HISTORIC AND DESIGN REVIEW COMMISSION

December 21, 2022

HDRC CASE NO: 2022-574
ADDRESS: 145 NAVARRO ST
LEGAL DESCRIPTION: NCB 986 LOT 11 THRU 13 AND E 5.14FT OF 10
ZONING: D, H, RIO-3
CITY COUNCIL DIST.: 1
APPLICANT: Peter Ketter/Sandvick Architects Inc.
OWNER: Kunal Mody/145 NAVARRO LLC
TYPE OF WORK: Construction of a rooftop addition, fenestration modifications, window replacement, rehabilitation, canopy installation and signage
APPLICATION RECEIVED: December 02, 2022
60-DAY REVIEW: Not applicable due to City Council Emergency Orders
CASE MANAGER: Edward Hall
REQUEST:

Proposed Exterior Alterations
HDRC Conceptual Review – December 2022

TITLE:	Storefront Elevations
DRAWING NUMBER:	A0.7.3
SCALE:	3/4" = 1'-0"

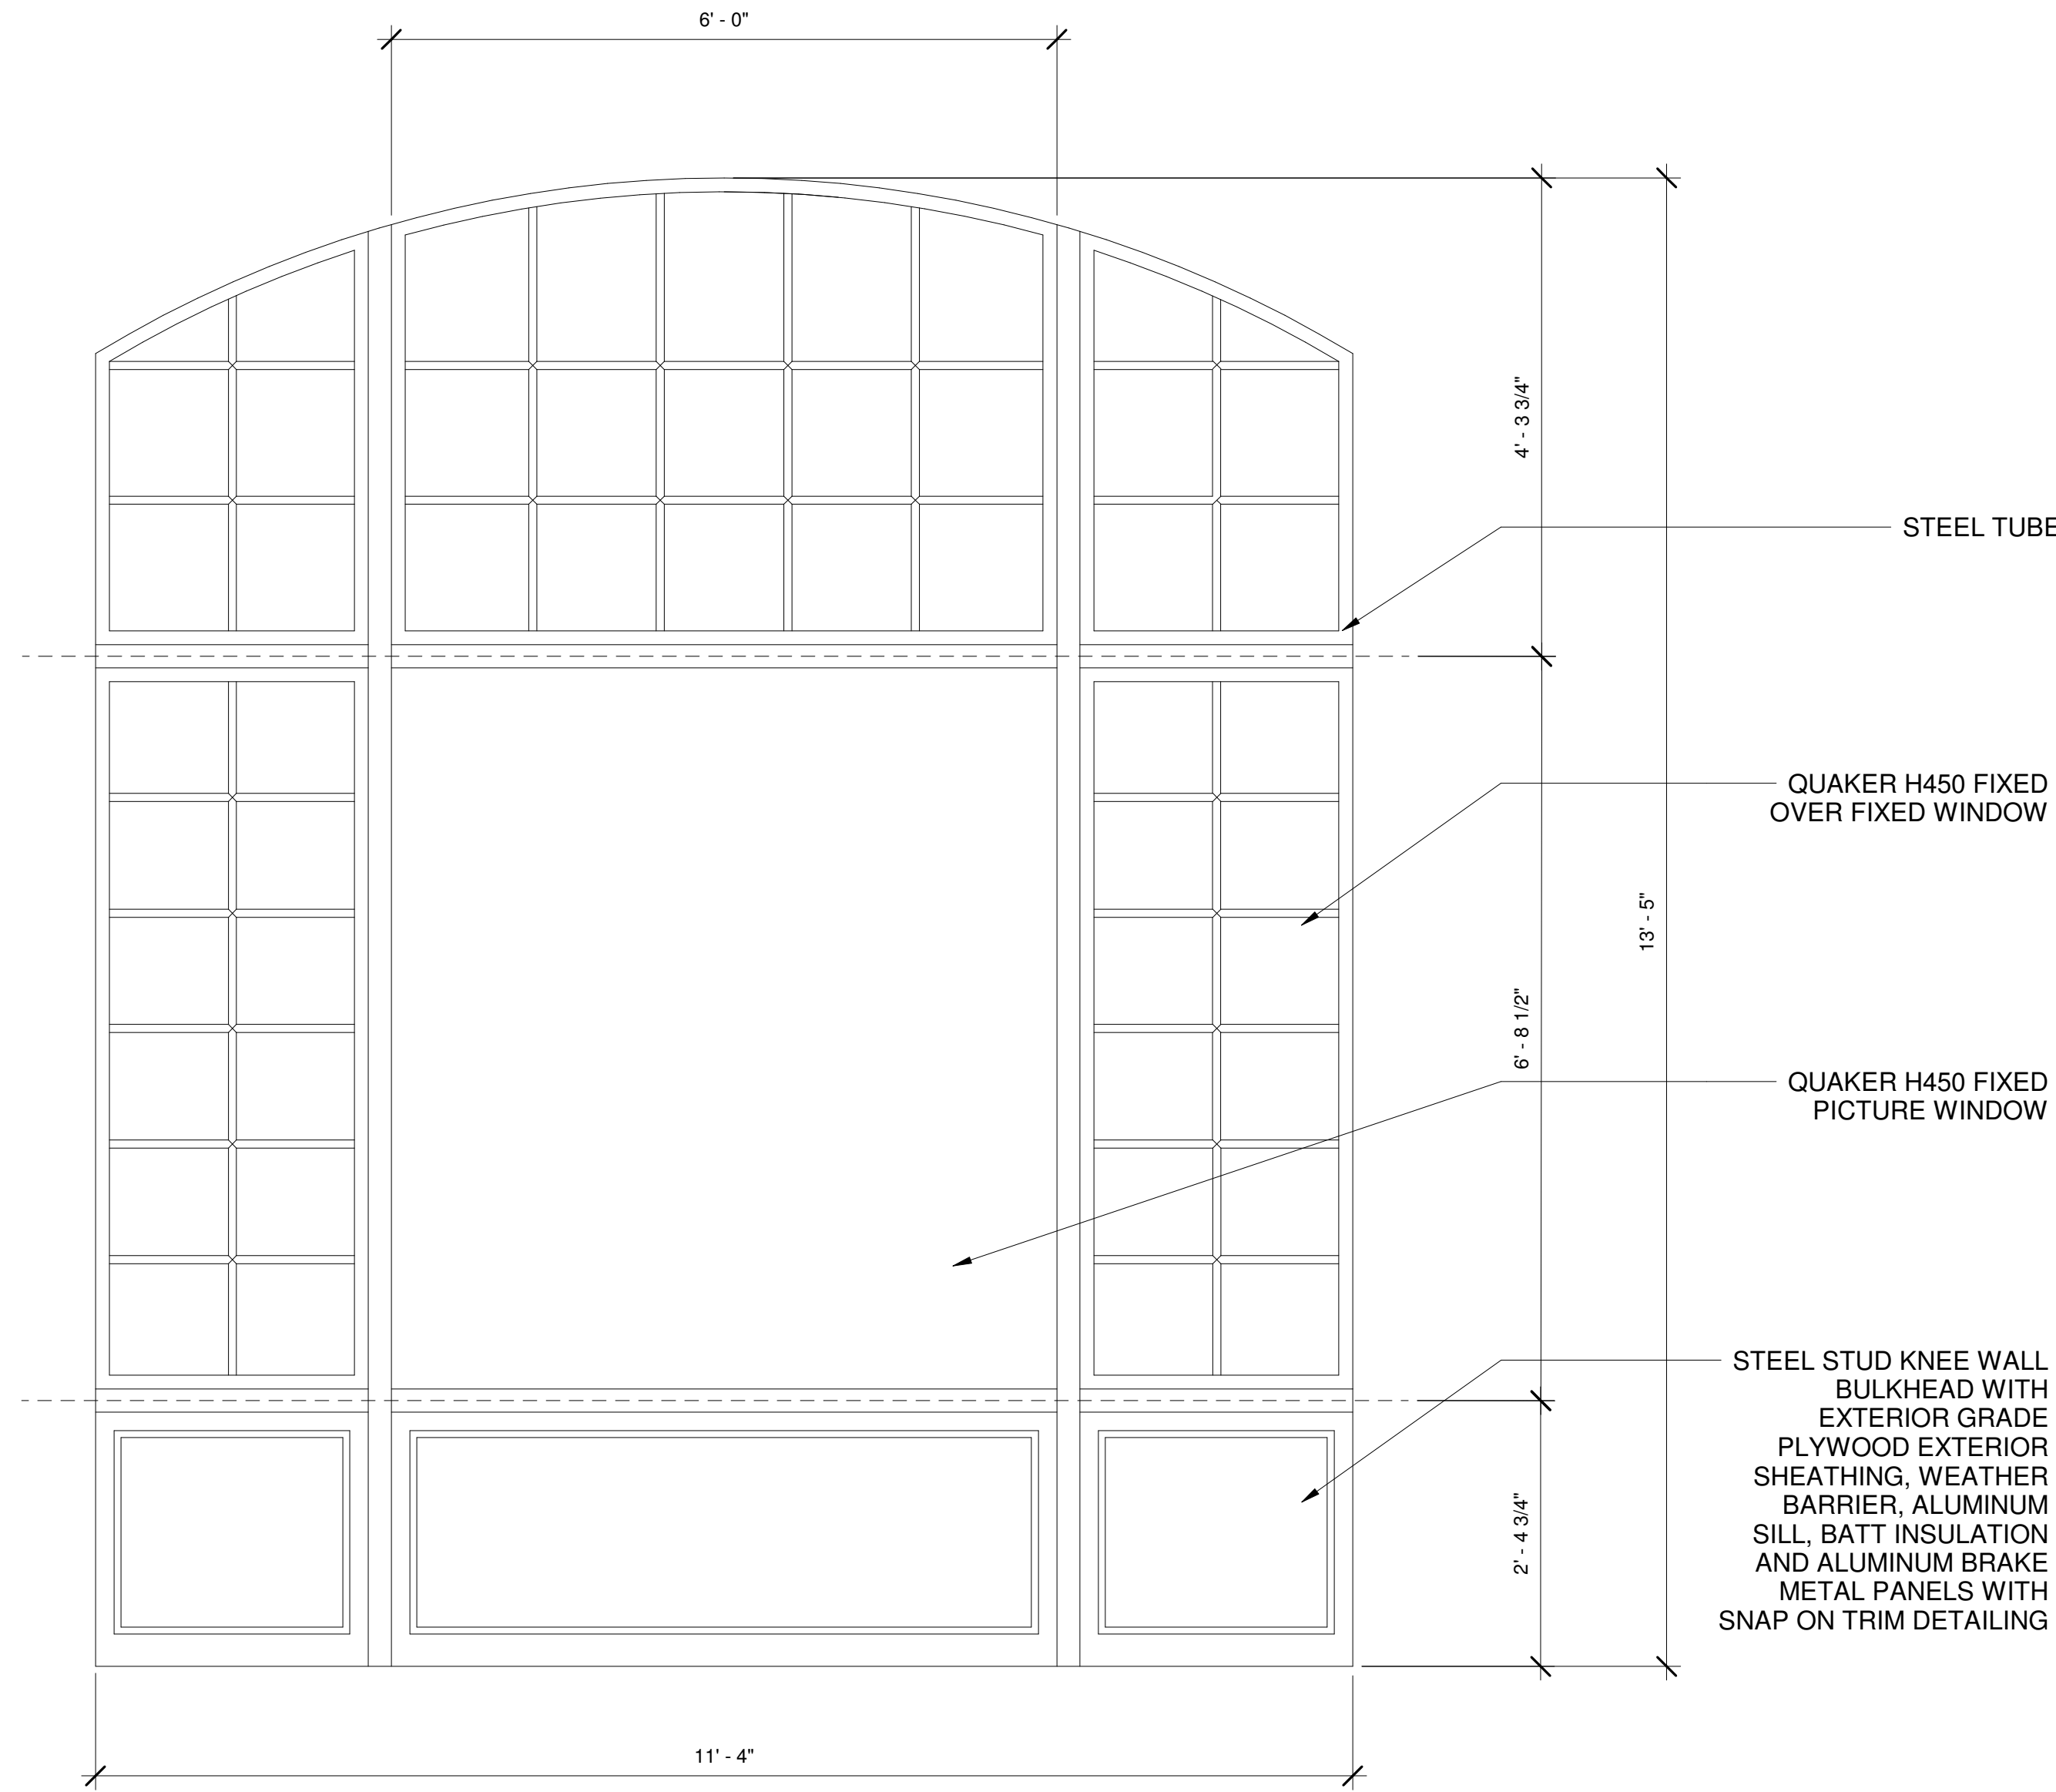
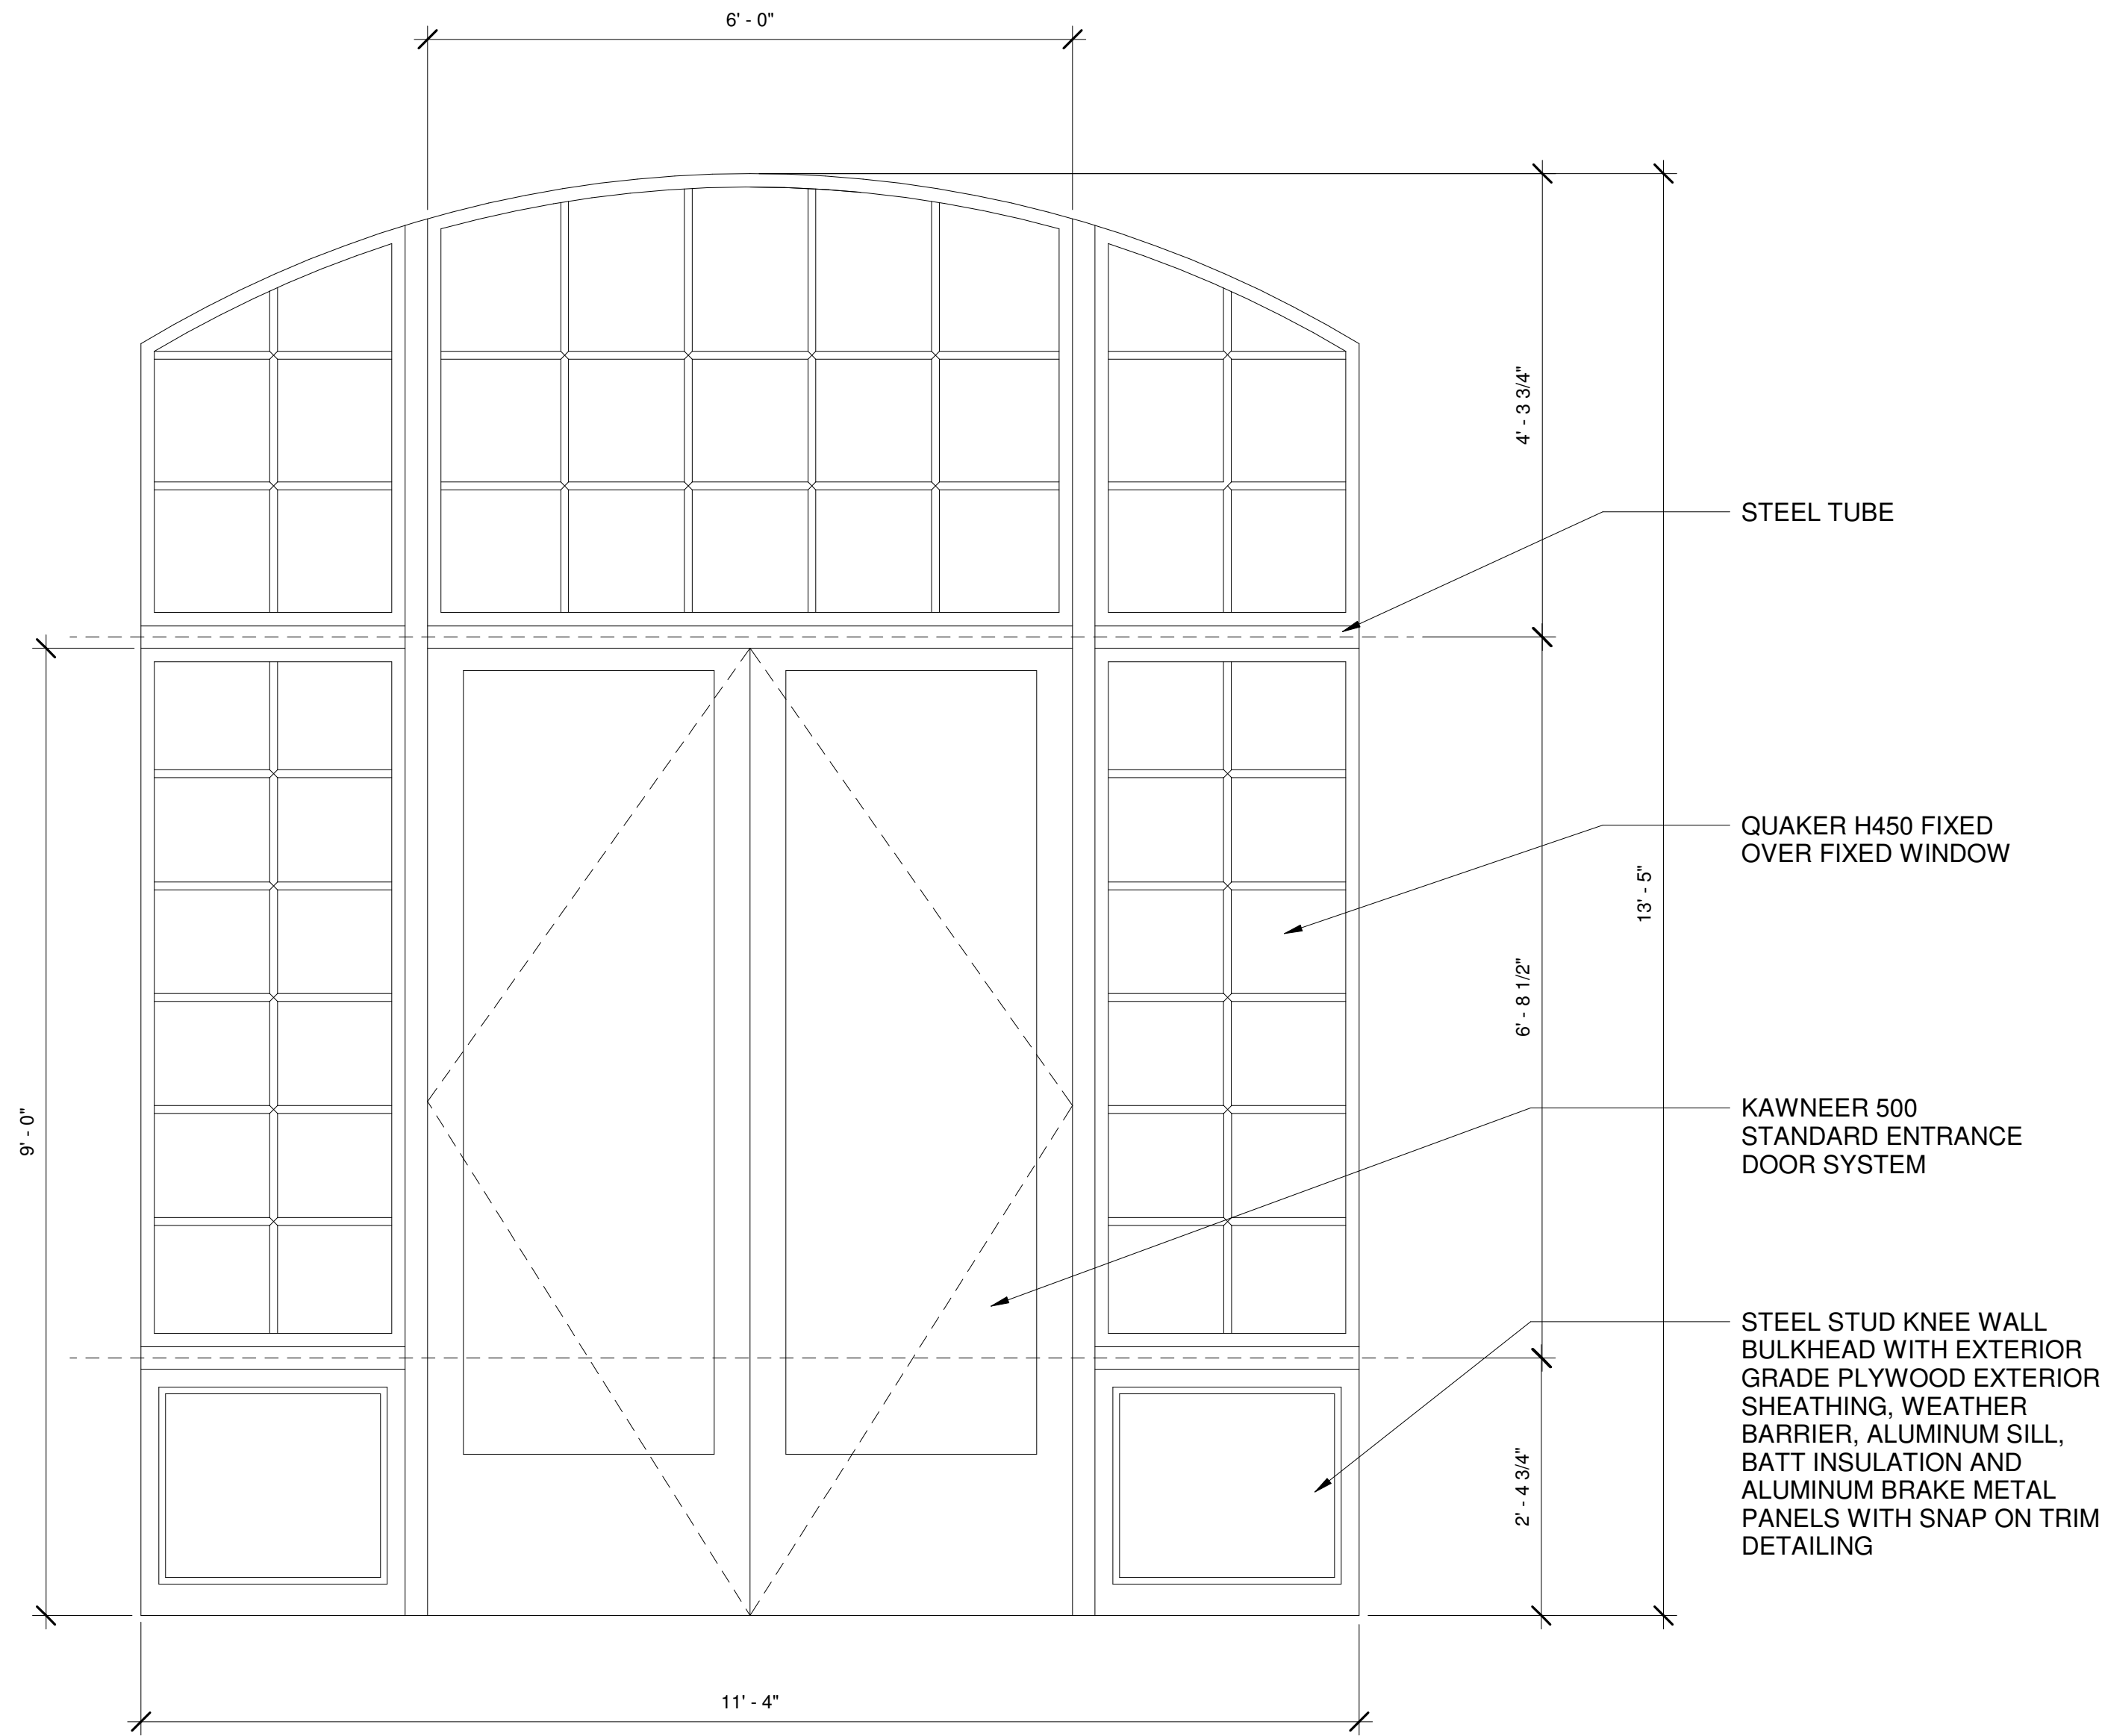
- e. **STOREFRONT SYSTEM REPLACEMENT** – The applicant has proposed to replace the existing, non-original storefront systems with new, aluminum storefront systems. Per historic photos, the original storefront systems featured one large, central pane with smaller, divided lites. The applicant has proposed to match this profile. Generally, staff finds the proposed replacement storefront systems to be appropriate; however, staff finds that each should feature dark colored frames and system components.

- i. That storefront system frames and their components feature dark colors.
4. Staff recommends approval of item #4, storefront system installation, based on finding f, with the following stipulation:
